Reference: **TB 0201 (04/2026)**

Technical Bulletin

Installation: Air conditioning unit clearances from open flames and ignition sources

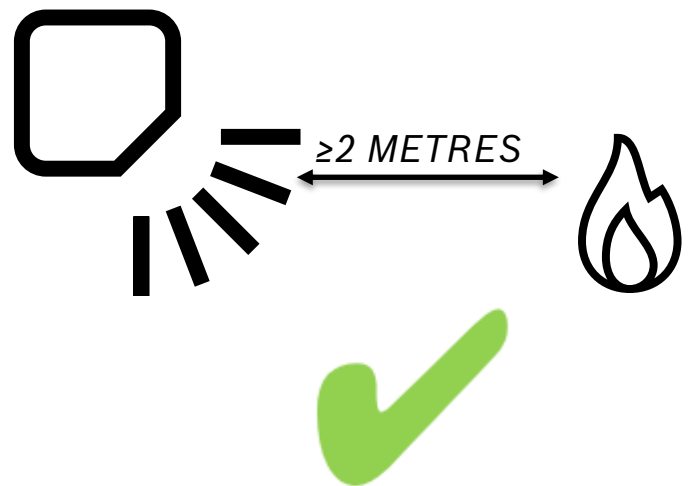
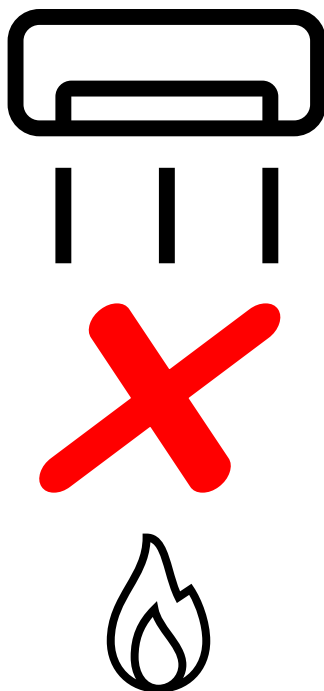
Do not install the indoor unit in a room in which open ignition sources (for example: open flames, an operating wall mounted gas boiler or an operating electric heating system) are in operation.

While consideration should still be taken to installation locations, room volume and amount of refrigerant in the system. We have now reviewed the installation manual statement and can confirm an air condition unit **can** be installed into a room with an open flame or ignition source providing that the below guidance is followed.

Do not install the air conditioning unit directly above an open flame or source of ignition.

Install the air conditioning unit with a minimum of 2 metres clearance from an open flame or source of ignition.
